Preliminary Consultation + MAP  
P865, P811 1991 5815 Hawkins Lane  
Hawkins Lane Historic District

I have reviewed your approved Historic Area Work Permit and after making a site visit, my findings are:

# APPLICATION FOR HISTORIC AREA WORK PERMIT

**DEVELOPMENT PLANS**  
**For**  
**8813 and 8817 Hawkins Lane**  
**Chevy Chase, MD. 20815**

FRONT ELEVATION  
SCALE: 1/8" = 1'-0"

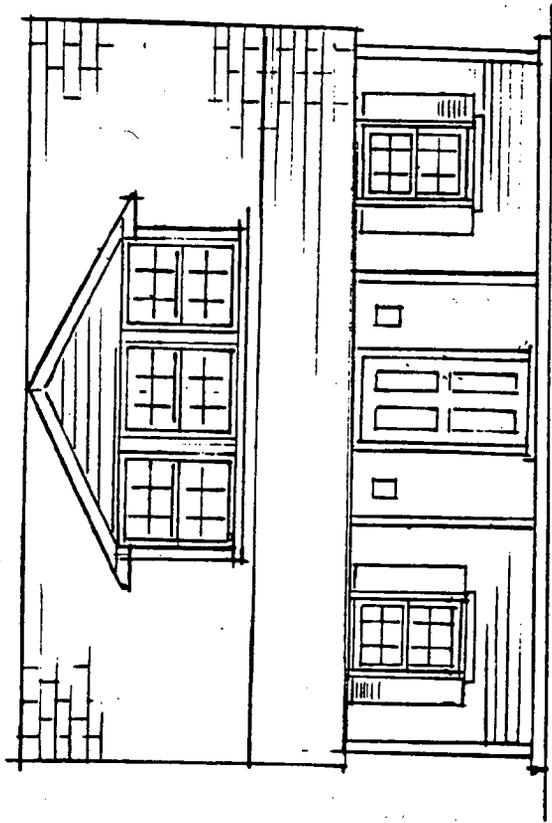
ALL WINDOWS NO. 1/1 TRIMMED  
ALL WINDOWS EXCEPT FRONT DOORWAY  
1/4 SHUTTERS ON WINDOWS  
NO SHUTTERS ON WINDOWS - JHP

\* ALL TRIM TO BE  
NEED. JHP

SIDE ELEVATION

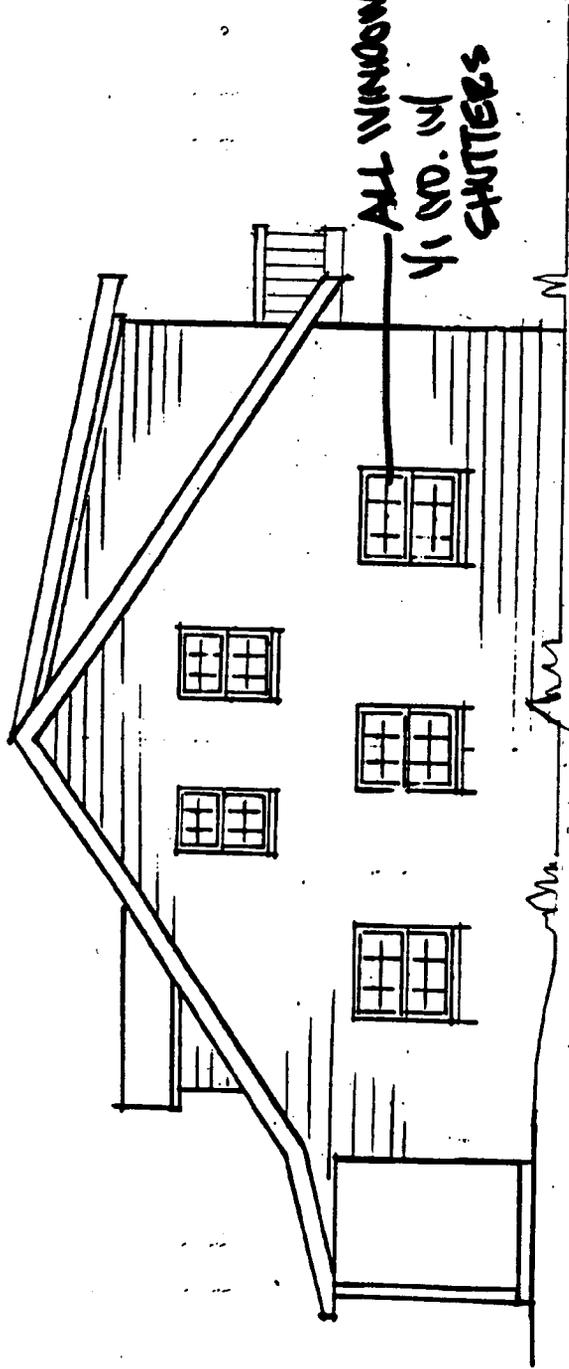
DELETE: ONLY ONE SLIDING GLASS DOOR PER FL. (php)

WINDOWS OF TRADITIONAL CONFIGURATION & SIZE. (php)

8817 Perspective View from  
Hawkins Lane. Rear dormer will not be  
Visible.

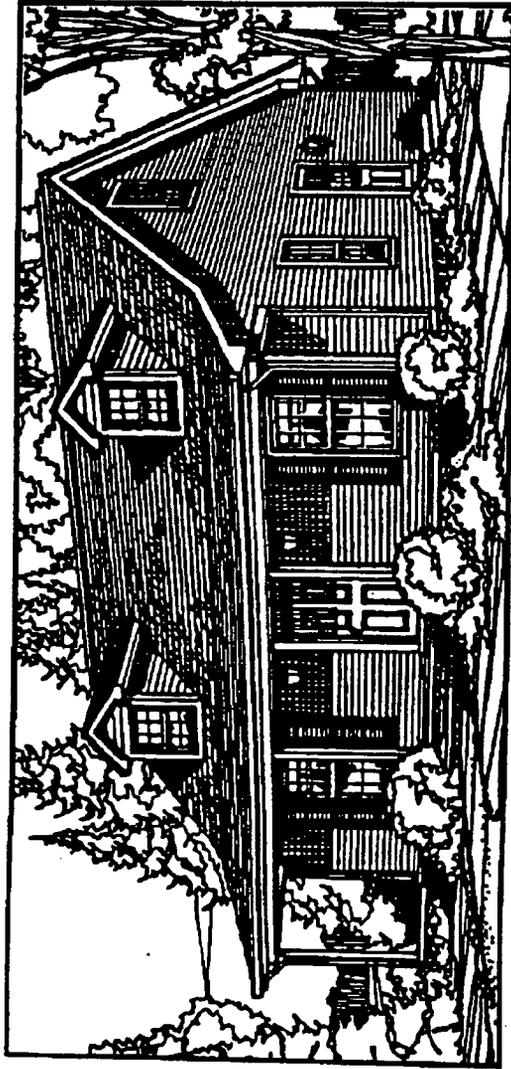
**\* CENTER DORMER ON REAR ELEVATION, PHP**

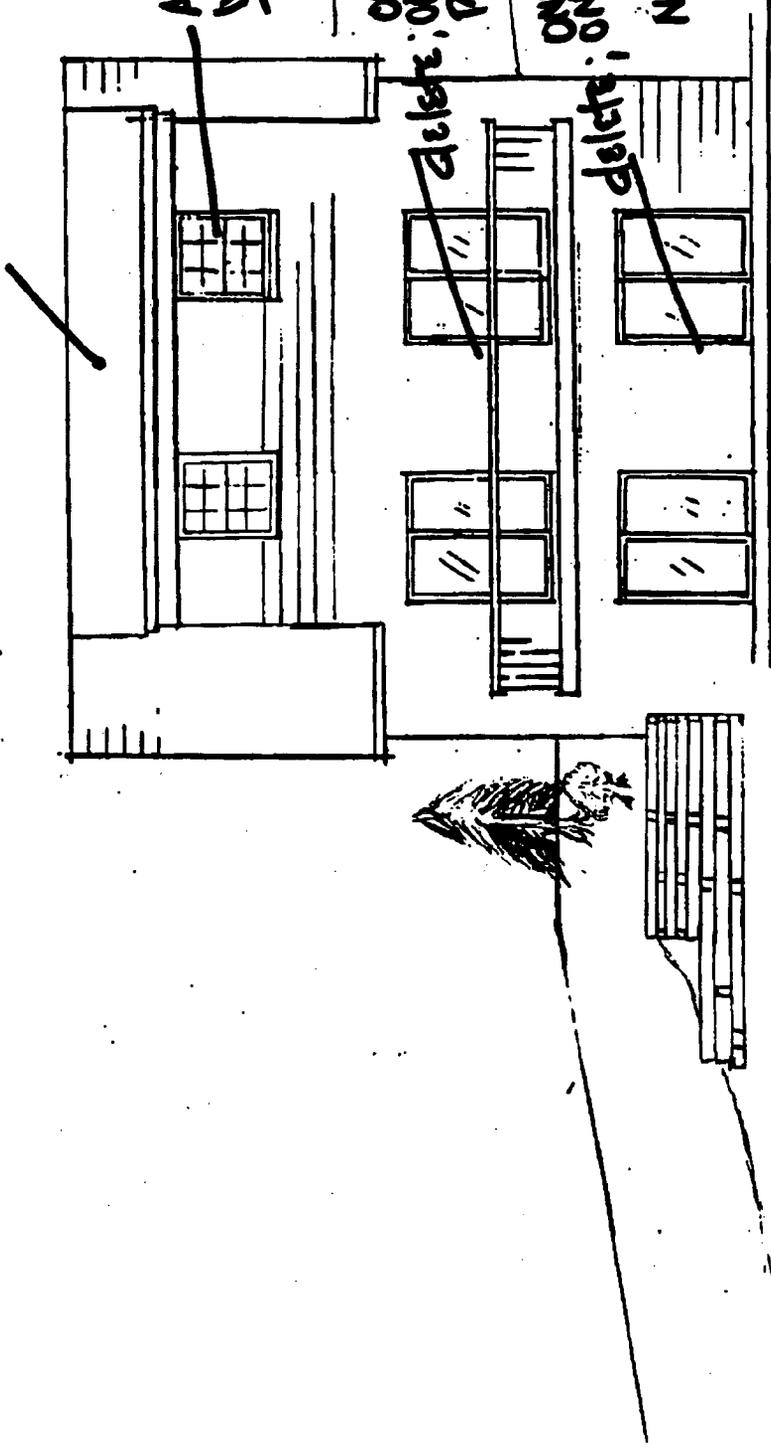
20" REAR DORMER TO BE CENTERED THIS ELEVATION

8817 Perspective View from  
Hawkins Lane. Rear dormer will not be  
visible.

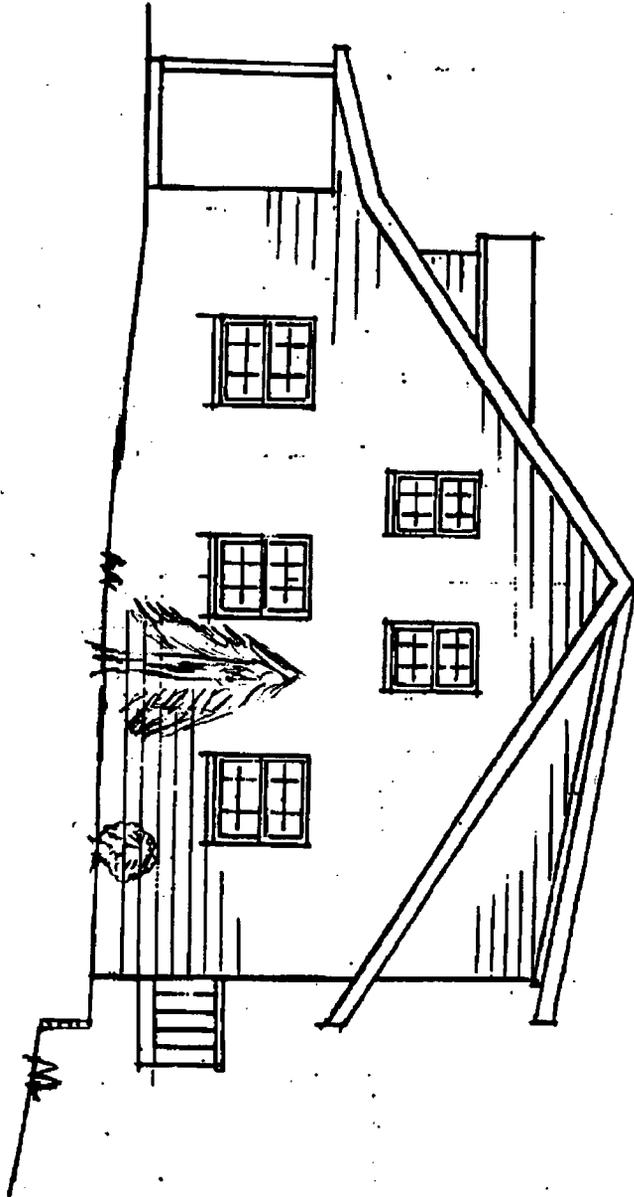
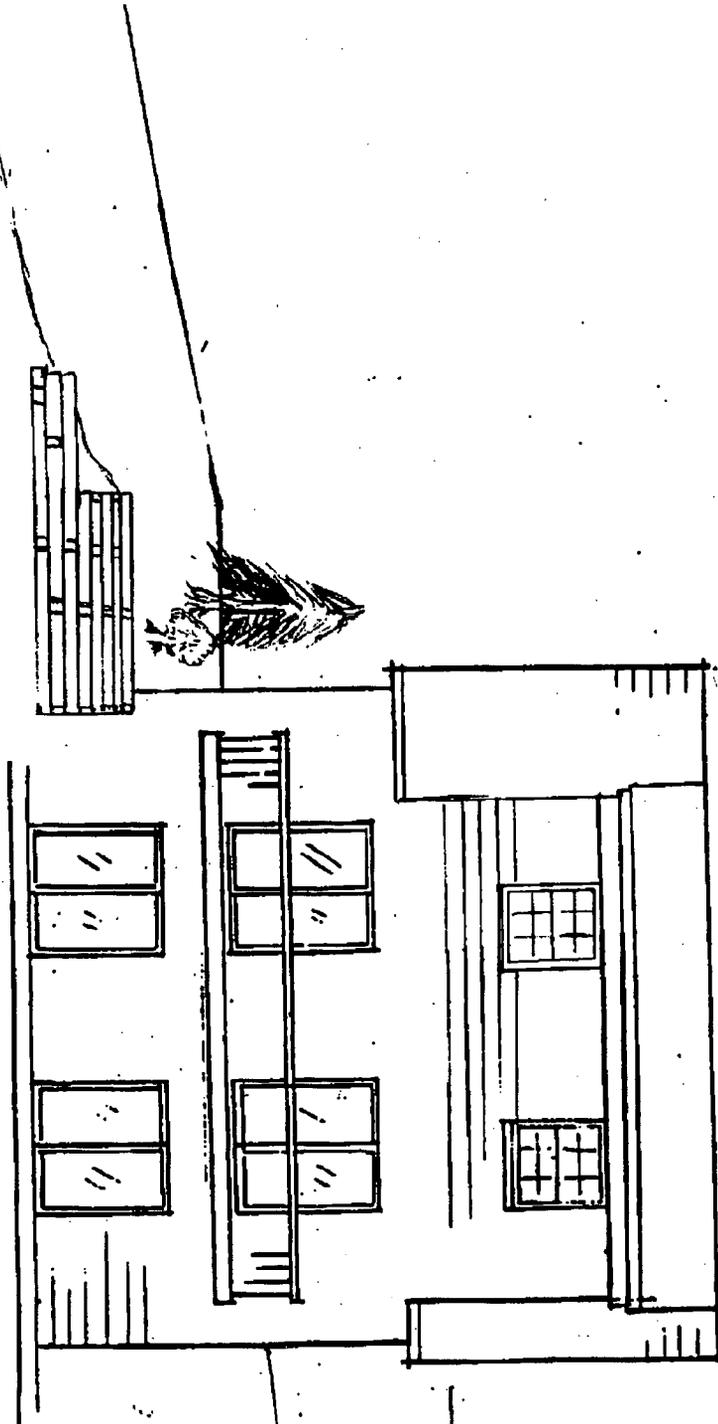
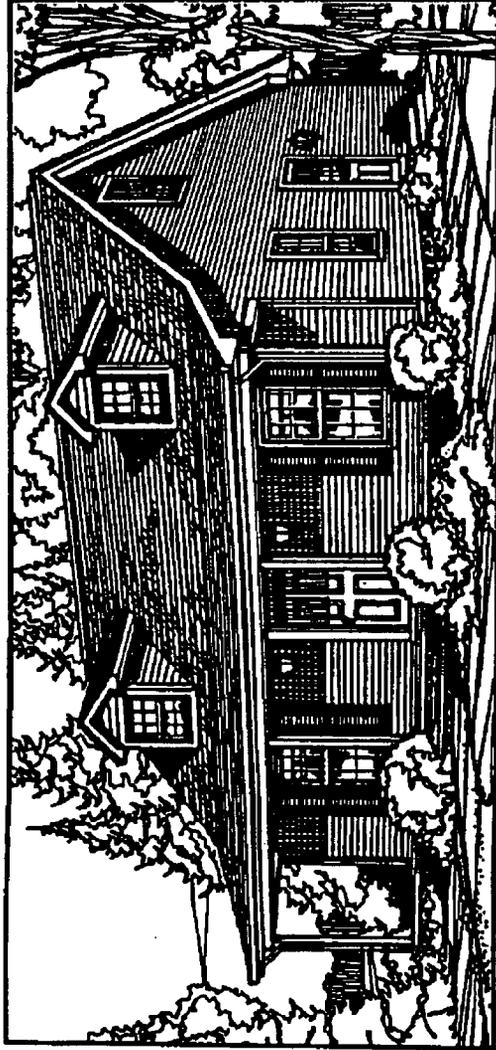
This is an option in response to your recommendation of the deletion of the rear dormer for the proposed house at 8817 Hawkins Lane. Through conversations with you, I have understood that the problem posed by the rear dormer would be that it gave the house two large of a feeling from the south side. The north side of the house would not be a problem due to the natural slope of the lane. Below are the changes that I will make in my proposal.

- The south side of the rear dormer will be brought further away from the side of the house. It will be 6 feet in. This will make the dormer 20' wide in total.

- The use of the fill dirt taken out of the basement will be used to raise the grading on the south side of the house. This will give the house the feeling of being only two stories. A 6"x 6" pressure treated railroad tie retaining wall will be incorporated.
